**PRODUCT CHANGE NOTICE**  
**PCN Form (D4-E000-73)****PCN#20-023**

<b>BPF-300A-1+</b>	<b>BPF-1000A-1+</b>
<b>BPF-V300+</b>	<b>BPF-V1000+</b>

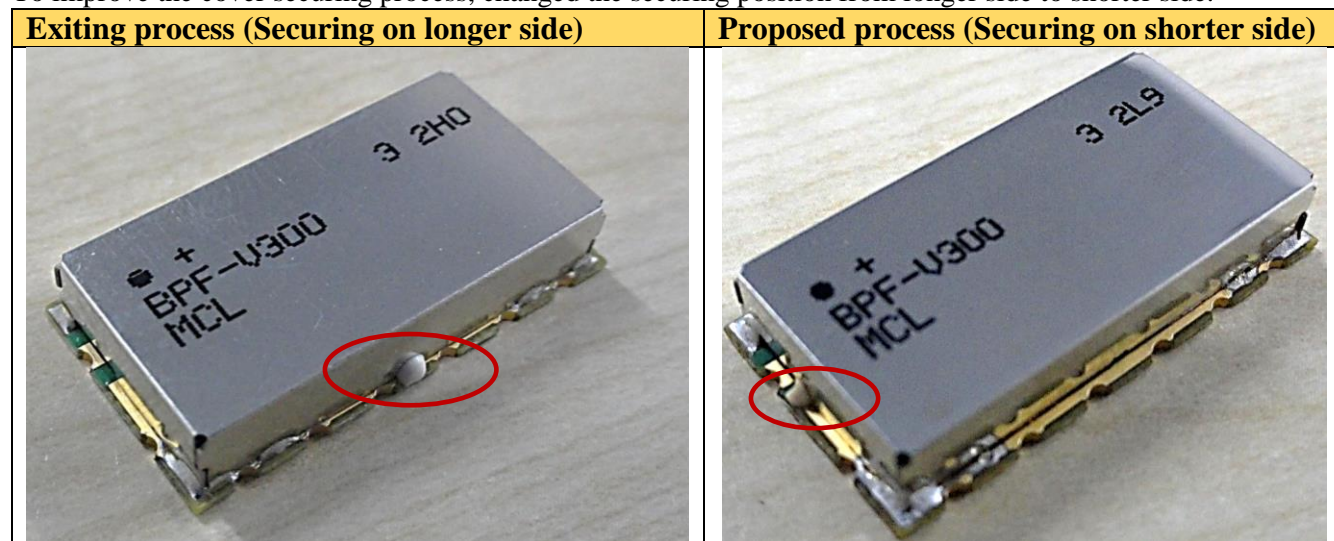
To improve the cover securing process, changed the securing position from longer side to shorter side.

**EFFECT OF CHANGE:**No change to **FIT** (dimension) or **FUNCTION** (performance).  
Change to **FORM** (appearance) due to Epoxy position changed.**REASON FOR CHANGE:**
